# CITY OF ALBUQUERQUE

RE: **Lot 12 Block 8 Unit 22 SAD 228  
6312 Canavio NW  
Volcano Cliffs Subdivision  
Grading and Drainage Plan  
Engineers Stamp Date 4/6/2021 (D10D003E12)**

## DRAINAGE AND TRANSPORTATION INFORMATION SHEET (REV 6/2018)

|  | GRADING AND<br>DRAINAGE PLAN | DATE<br>3-18-21          |

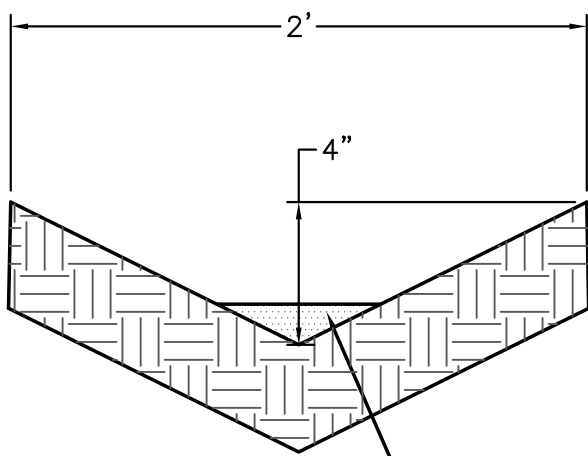
Based upon the information provided in your submittal received 4/6/2021, this plan is approved for Grading Permit.

**Prior to Building permit approval a Pad Certification will be required, provided by the Engineer or a registered Land Surveyor.**

**Advise the owner contractor not to use dirt as a ramp to climb the curb, use lumber or crusher fines for this purpose.**

Reiterate to the Owner/Contractor that a separate permit for a garden/retaining wall must be obtained with the approved G&D plan and Pad Certification. Also, if a swimming pool is to be placed the grading and drainage plan will change and will need to be resubmitted.

**Prior to Certificate of Occupancy release, Engineer Certification per the DPM checklist is required.**
